Mitsubishi hoist Sales & Service

Notice of a part for a 7.5ton hook block change

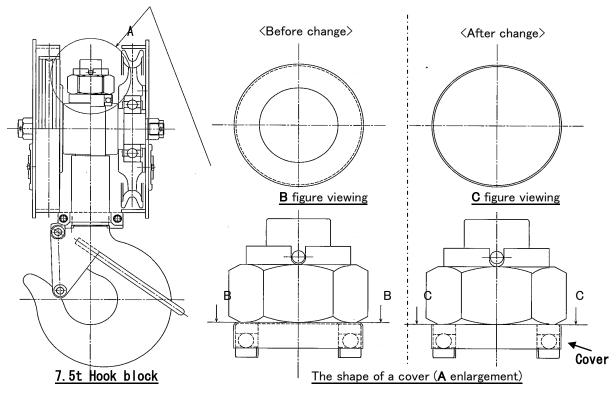
The shape of a cover which is in the thrust-bearing part is changed.

This change has compatibility with former cover.	Part Code	Part Number
(The shape is only changed)	03H435	2581211
<u>*The Part Code for service parts is not changed</u>
